Product Change Notification (PCN)

PCN Number	511152	Date Issued	November 05, 2021
Reason for Change	Capacity change or tool replacement		
Change Type Description	This letter is to inform you that another set of tooling is being added to meet the current and future demands of this product. There will be no changes in the fit, form or function from the additional tooling when compared to the current tooling.		
Reason for Short Notice	Corrective Actions		
Assessment of Change	First article inspection		
Internal Molex Qualification Date	November 10, 2021		
Sample Availability Date (Changed Part)	November 10, 2021		
Planned Implementation Date	December 05, 2021		
Method of Identifying Change	Lot information on label

Mold refurbishment for 540170615 and 540180605

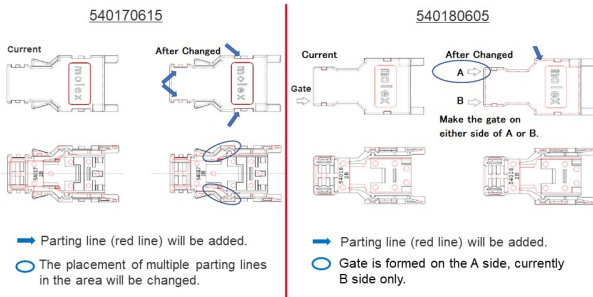
- Restore productivity by refurbishing mold for 540170615 and 540180605.
 - The parting line and gate position on the product surface will be changed as attached picture.
 - The mold number marking will be changed from A to B.
- Product Impact
 - The parting line and gate position on the product surface will be changed. But there are no impact to fit, or function
- Part Number Impact
 - see attached impacted parts list
- How the change implement
 - Running change
- This product is manufactured at Japan supplier and this change will only impact Molex Japan supplier.
- Qualification Reports and samples available upon request after the date shown above
